10/580,198

Office Action Summary

Group I, claim(s) 18-25, drawn to a multilayered PWB.

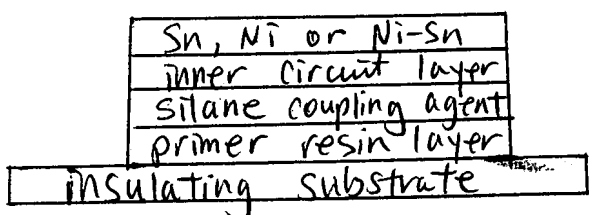
Claims 18-20 are structurally indefinite, as it is unclear the positional relationship between the primer resin layer, the inner circuit, the insulating resin layer, the surface layer, the Sn, Ni or Sn-Ni and the silane coupling agent layer? Applicant is required to clarify where each layer is located with respect to the other layer.

As for the time being, the examiner is taking these layers as following:
